## **REQUEST**

**(PUD2002) Fairway Estates LP** (Glen Eagle PUD), Joseph Byker, 2905 Wilson Ave. SW, Grandville, is requesting REVISED preliminary and final planned unit development approval for parcels listed in the attachment and withdrawing the following parcels of land from the PUD:

**The Planning Commission is to consider the revised PUD preliminary plan and final development plan, minus the removed land, to determine if the reduced PUD still meets ordinance requirements. Smaller front yard setbacks from the already reduced 25 feet to 21 feet is also requested. No rezoning is needed for the remaining portion of the PUD because it is already zoned PUD.**

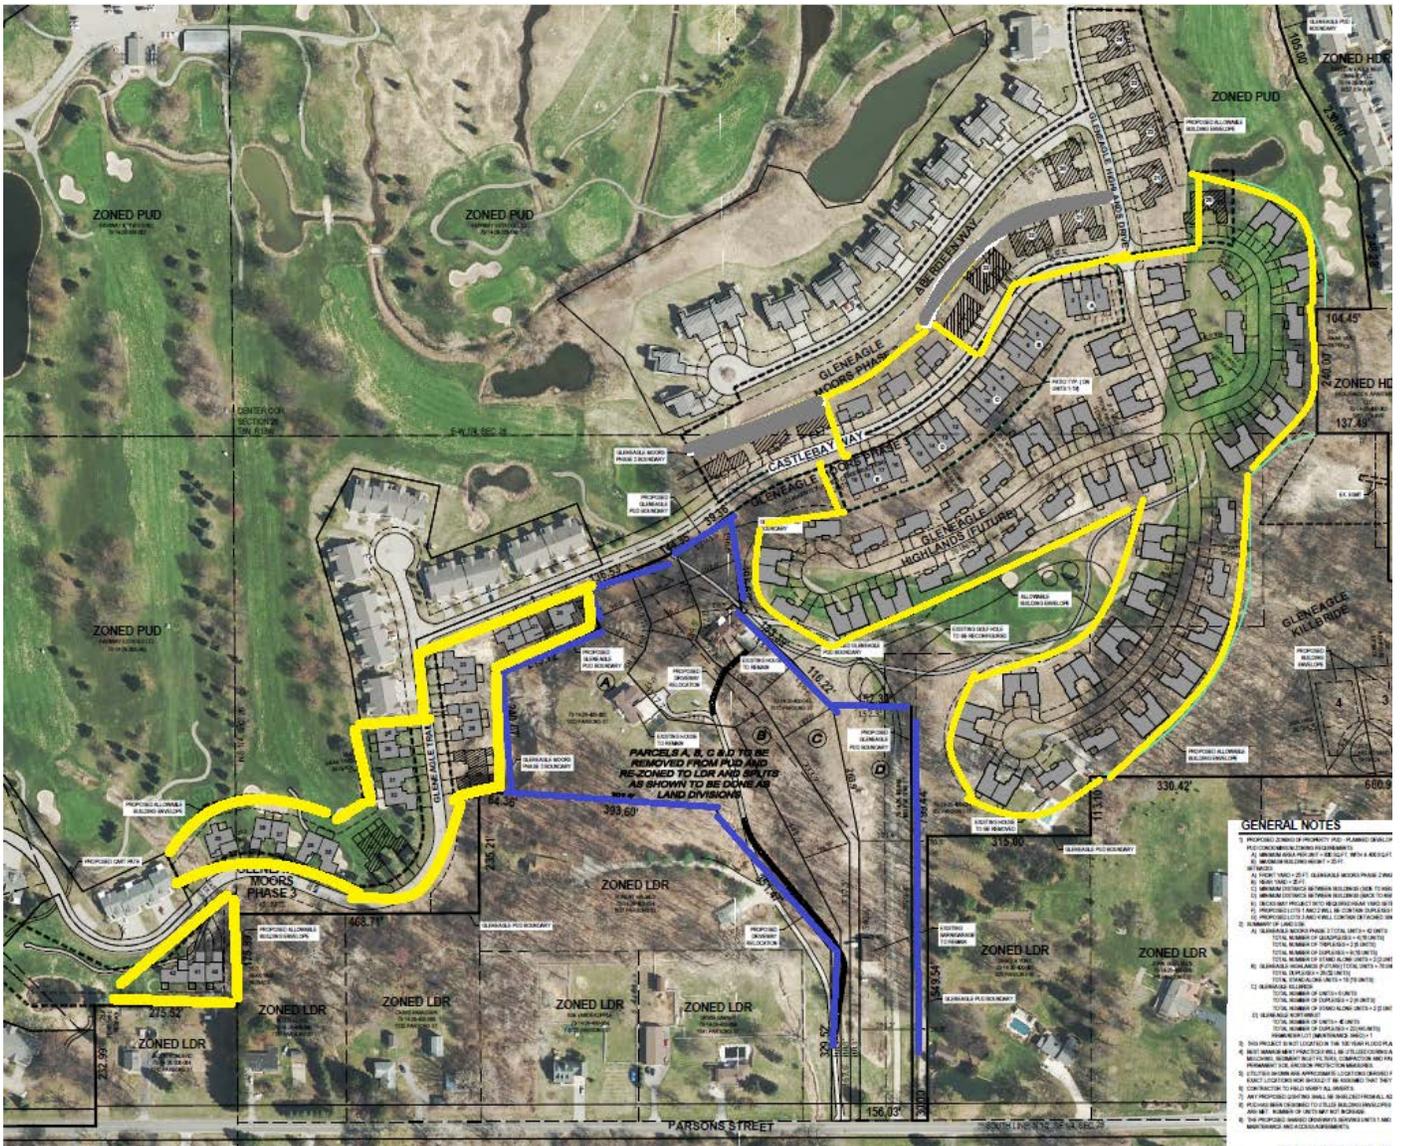
The proposal is to removed the land outlined in blue below, including the access to Parsons St., and to revise the layout, including the redesign of the condos in the areas highlighted in yellow.

Note that this revision will result in the future construction of 117 condos, along with the elimination of the access drive to Parsons St. **In response to the proposed elimination of this access point on Parsons St., the Township has received petitions signed by 68 residents of the Glen Eagle development requesting that the removal of this access point not be approved. The initial approved preliminary development plan showed the access to Parsons St. The residents do not want the additional vehicles from the proposed 117 condos to all have to use the existing private streets in their development to gain access to a public street. Their fears are the extra traffic, along with the extra wear and tear on their private streets. Plus this is different from what was intially approved and what they planned on being developed.**

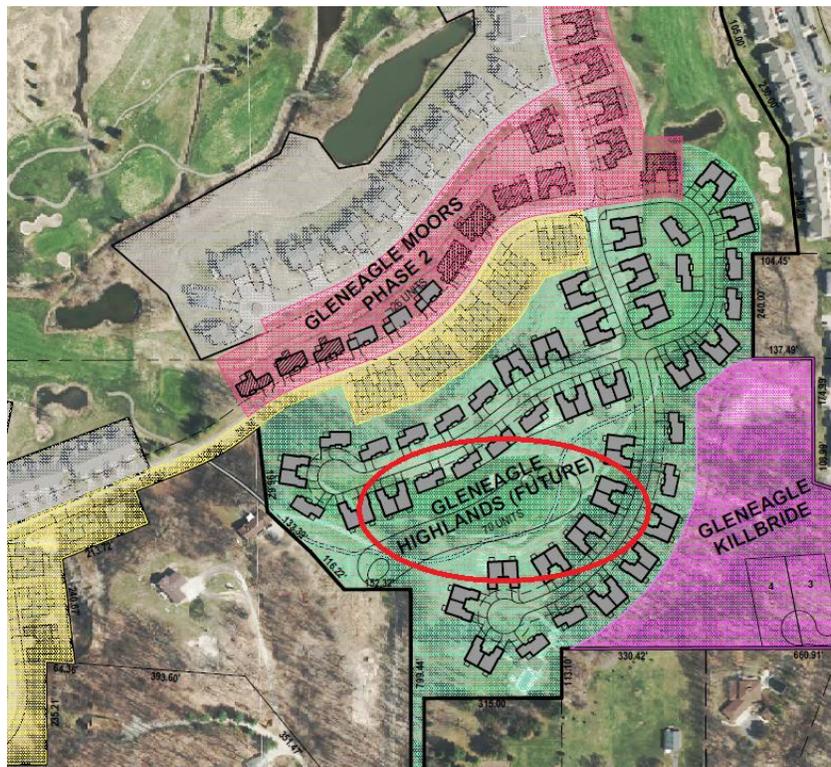
- d. Attached garages are proposed with 400 square feet in area, consistent with ordinance standards.
- e. Deviations were already approved for setbacks as follows (based on the HDR standards):
  - **Required - 30 foot front yard setback.** Previously approved - a minimum of a 25 foot front yard setback, except for a minimum of 21 feet for unit 19 in Phase 3, as well as the other 10 building in Phase 2 adjacent to Castlebay Way due to the major elevation changes in the rear yard.
  - **New Deviation request:** The applicant is now proposing the decrease the 25 foot front yard setback to a 21 foot front yard setback for the future Glen Eagle Highlands, consisting of 52 units. The reason provided was due to grade changes and to preserve the golf course. However, note that there would barely be enough room to park a vehicle in the driveway without it sticking out in the street.

The Planning Commission will have to determine if this is acceptable. Note the pictures below showing the 25 foot front yard setback compared to the 21 foot front yard setback.

- The required setback on Parsons is 40 feet. Proposed - 25 feet from the right-of-way line. The required setback on 8<sup>th</sup> Ave. is 100 feet from the centerline. Proposed – 103 from the centerline for the buildings, but only 60 feet for the shared driveway.
- Required - 15 feet side. Proposed – total of 20 between buildings.
- Required - 30 foot rear yard setback. Proposed - a minimum of 25 foot rear yard.
- Required - Chapter 24 footnote (j) requires a minimum distance of 25 feet between contiguous buildings. Proposed - a minimum distance from side to side of the building of 20 feet and a minimum distance from rear to rear of building of 40 feet.

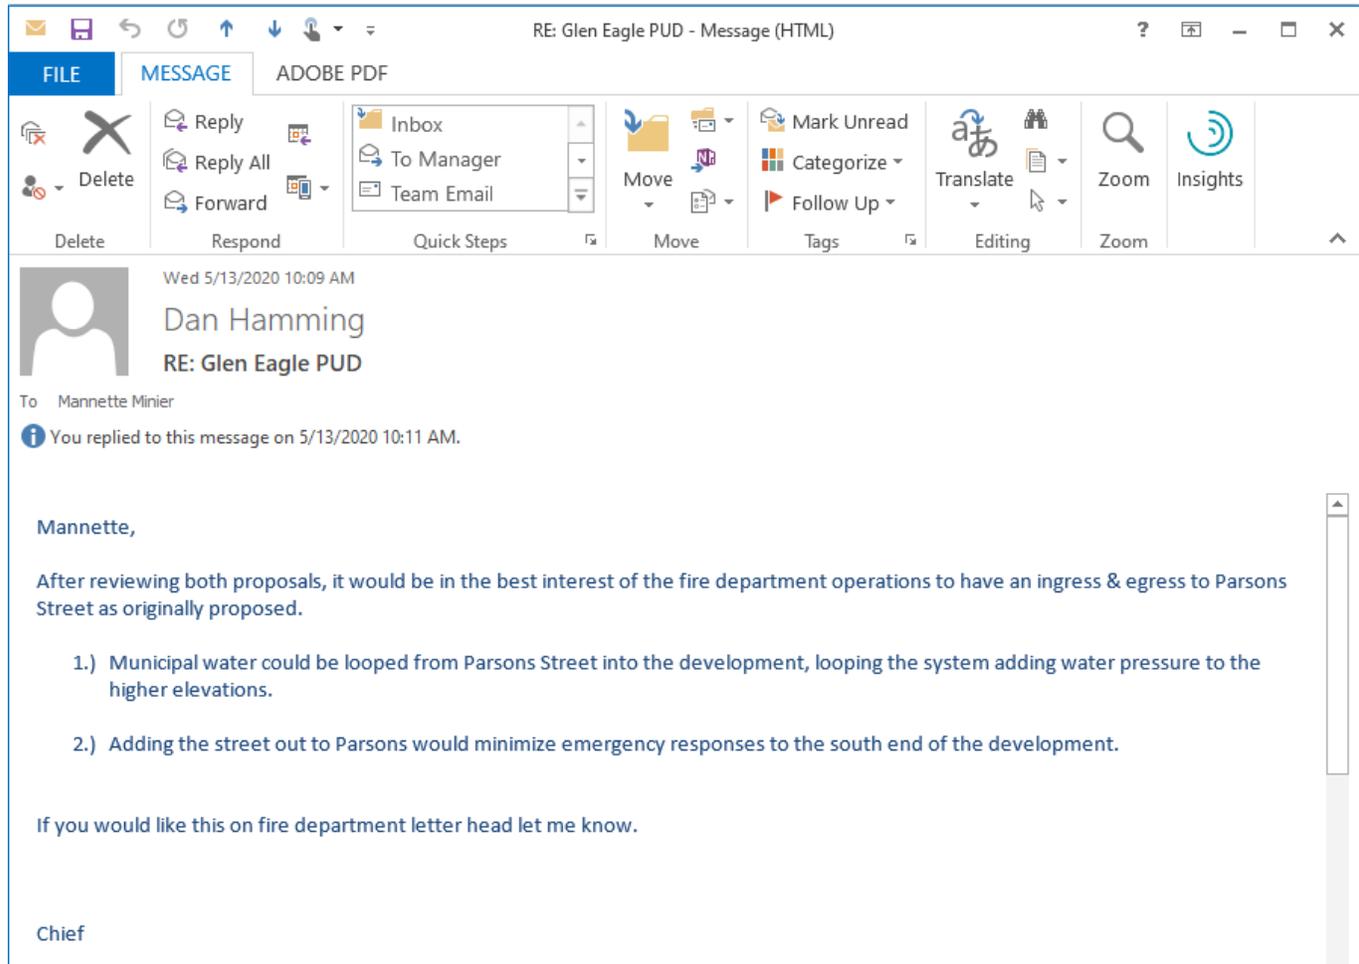
Based on the map below, basically there are 3 accesses along the northern boundary on 44<sup>th</sup> St. and 3 along 14<sup>th</sup> Ave. along the western boundary. The current access along Parsons St. does not provide interior access to the condos (see below), but only to the interior service drive to those four buildings.

The adjacent map shows the current access to public roads, including three on 44<sup>th</sup> St., three on 14<sup>th</sup> Ave. and the one on Parsons St. which does NOT provide access to the interior condos, but only provided access to the service street adjacent to Parsons.

Consequently, there are three access along the northern boundary, three along the western boundary, none that provides access to the interior of the PUD along Parsons and none to the east. The future access shown on the previously approved preliminary plan would be removed. No new additional access is proposed for the future 117 condos.

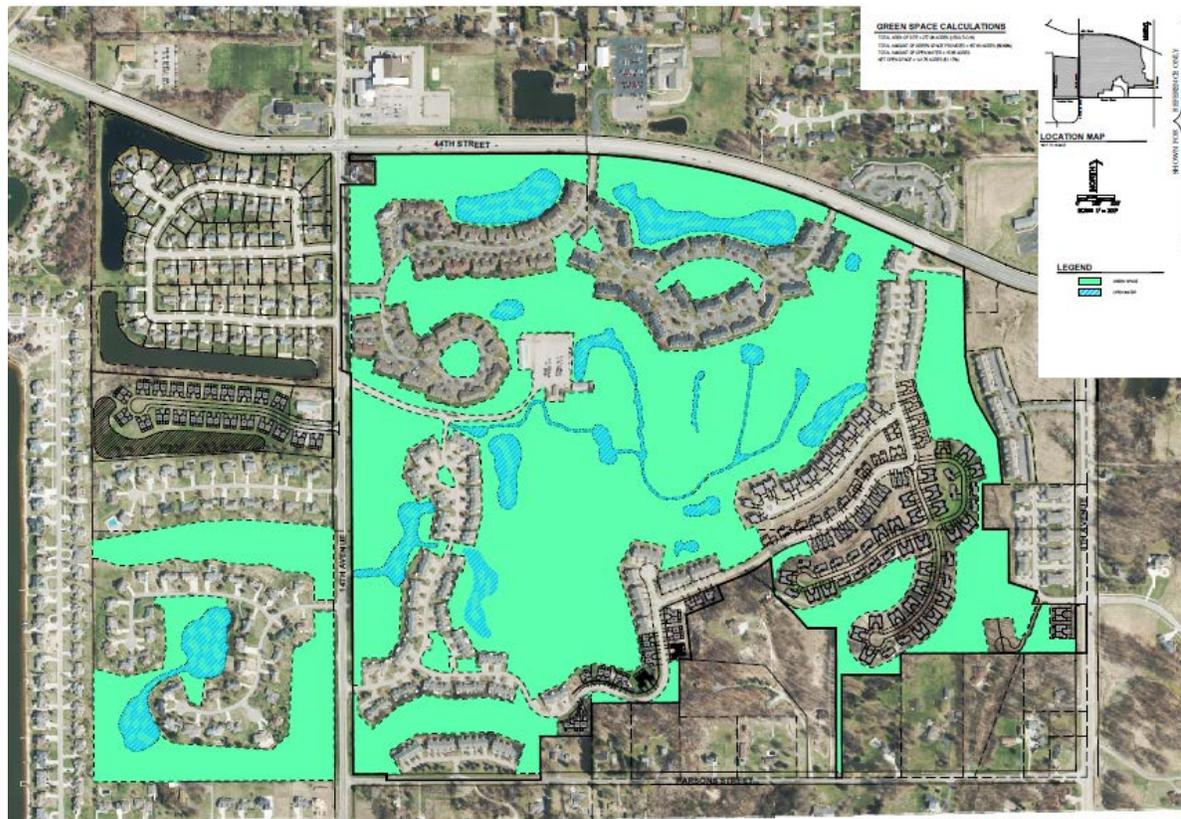
**This standard appears to be met with a note on the plan indicating that 47.06% of the property is open space, which exceeds the minimum amount required.**
